CITY OF ALBUQUERQUE

**RE: 908 Four Hills Rd SE
Grading & Drainage Plan
Engineer's Stamp Date: not signed
Hydrology File: M23D023
Case # HYDR-2025-00426**

Based upon the information provided in your submittal received 11/30/2025, the Grading & Drainage Plan **is not approved** for Building Permit. The following comments need to be addressed for approval of the above referenced project.

ENGINEER'S SEAL	LOT 1, BLOCK 9, FOUR HILLS VILLAGE, 908 FOUR HILLS ROAD SE	DRAWN BY MM
	GRADING AND DRAINAGE PLAN	DATE 11-28-2025
		SHEET # C1
DAVID SOULE P.E. #14522		JOB #

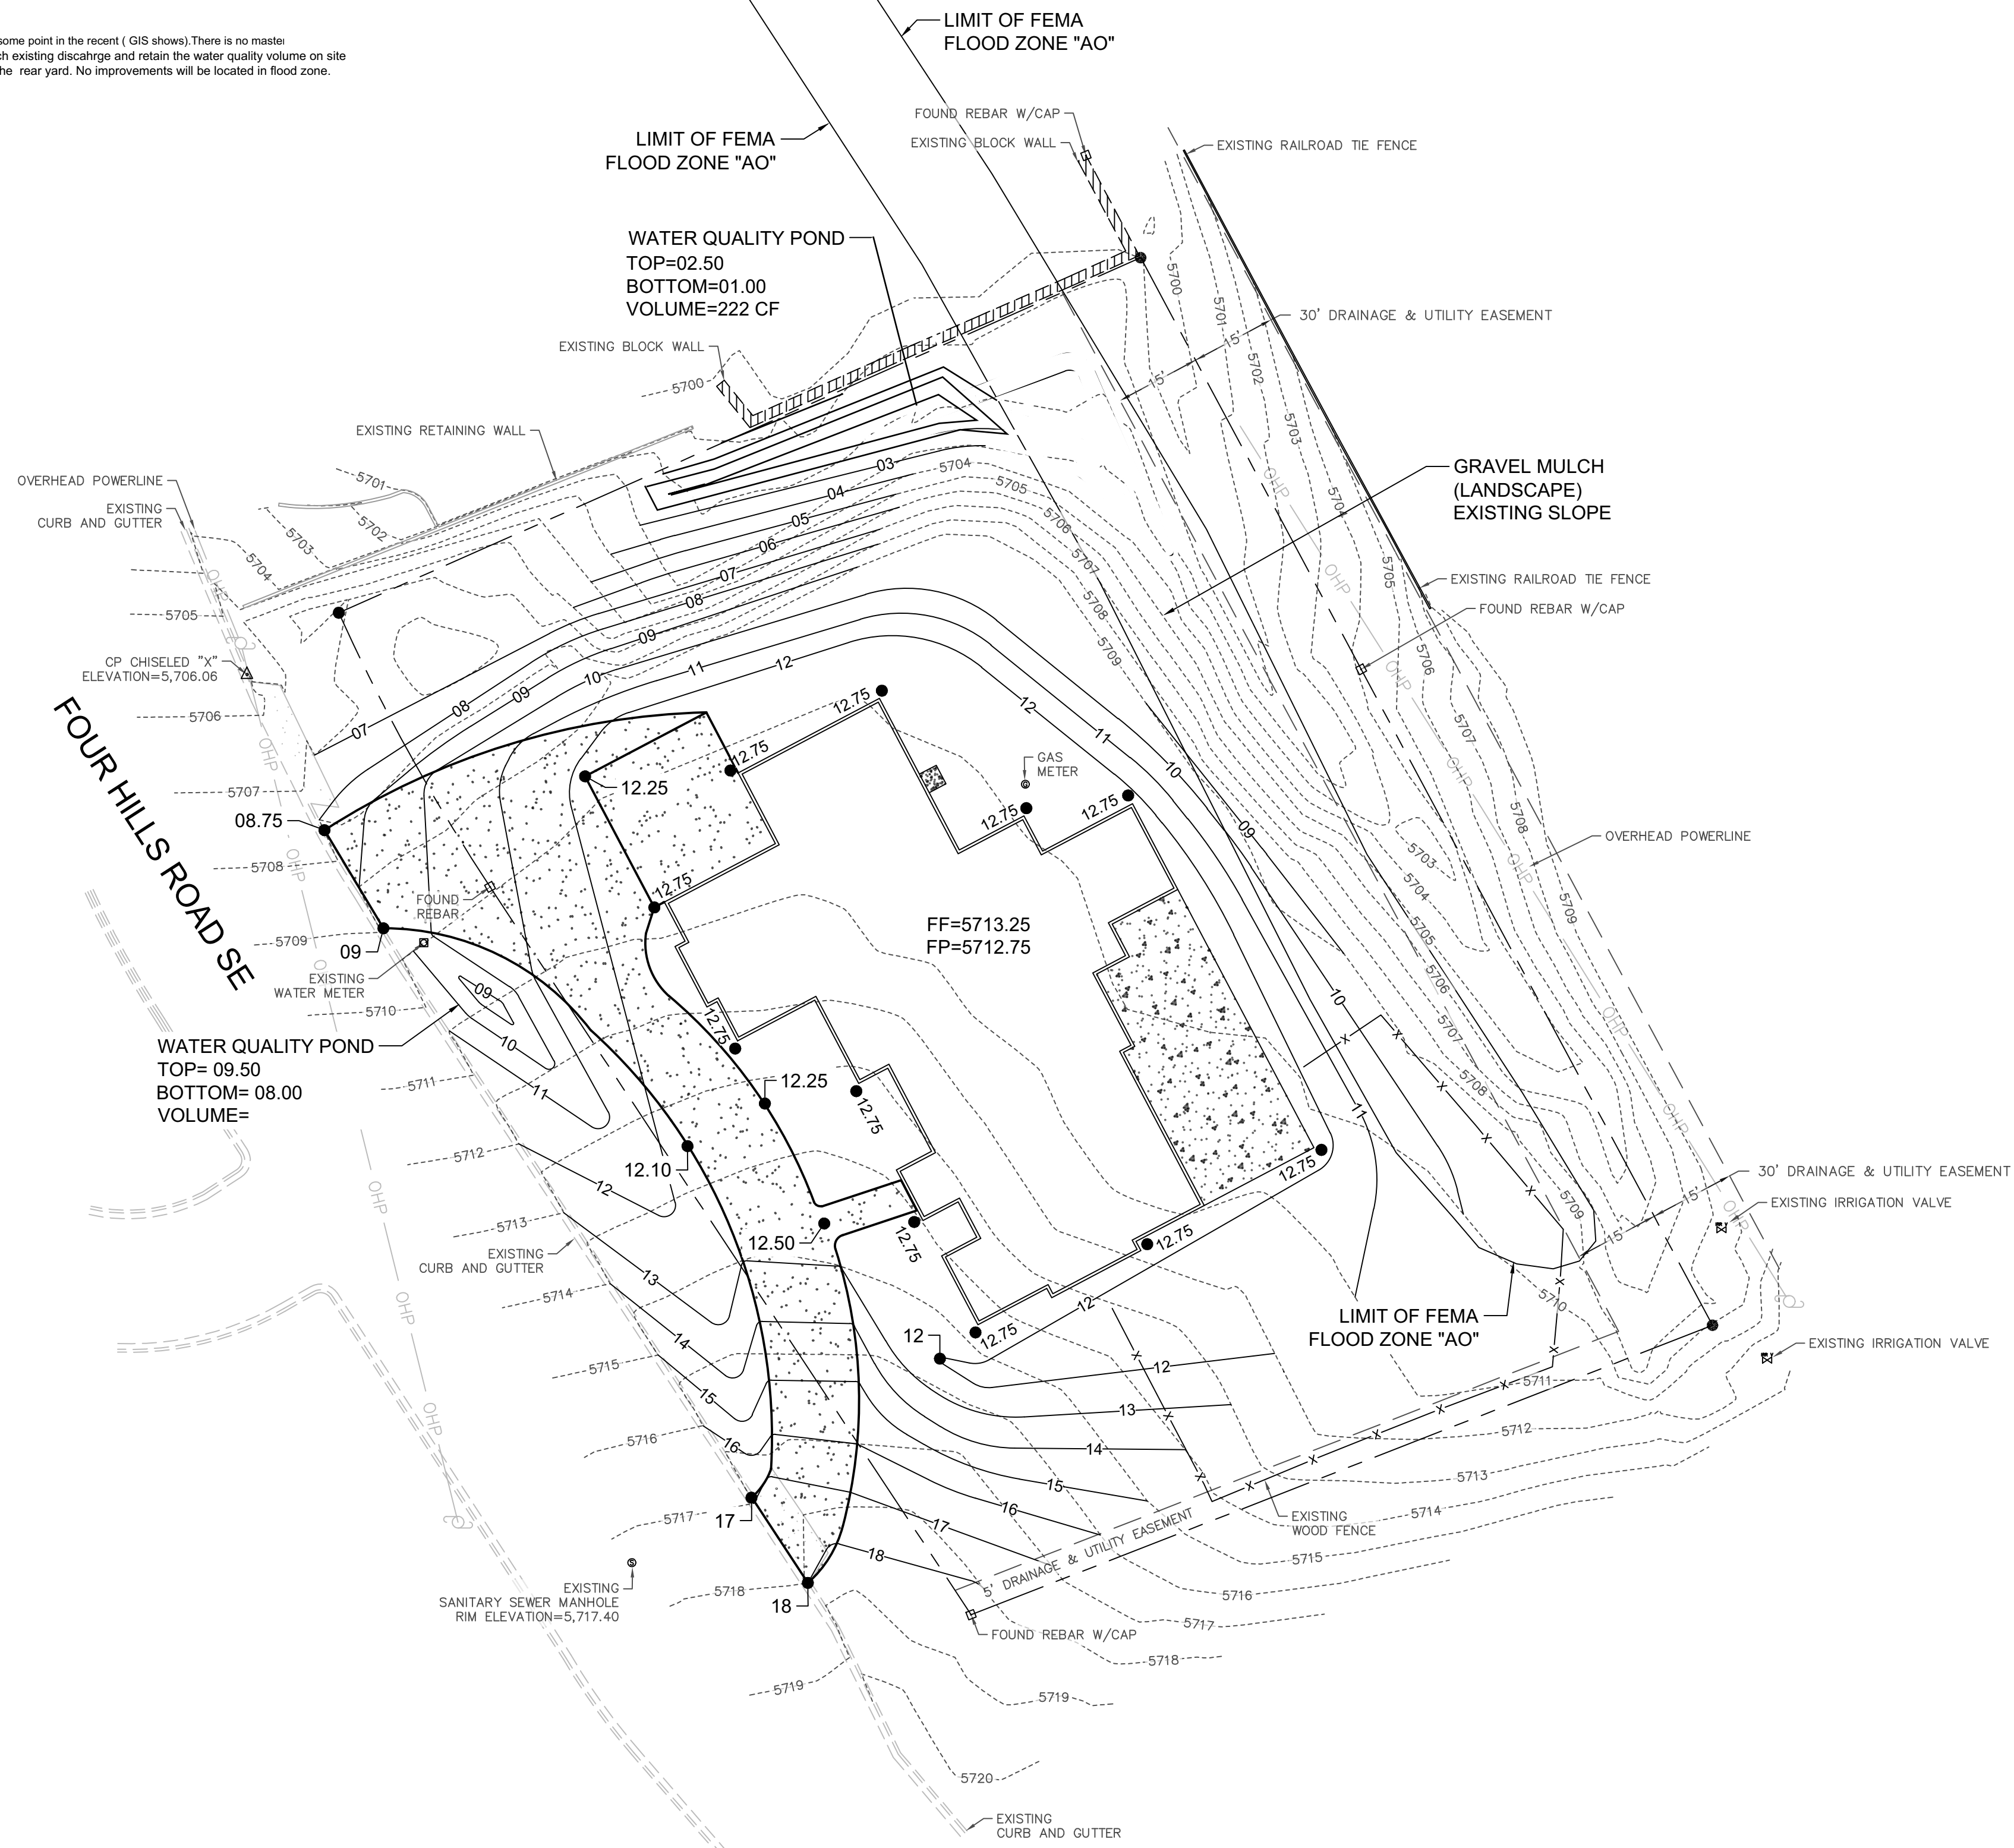
1. Per the IDO, the property owner of the property is responsible for building the adjacent half of Four Hills Road to include curb & gutter, and sidewalk. The project will have to go to the Development Facilitation Team (DFT) for approval of the Infrastructure List.
2. Please show the curb & gutter, and sidewalk on the plans.
3. Please provide an engineer's stamp with a signature and date.
4. Submit a Floodplain Development Permit for approval.
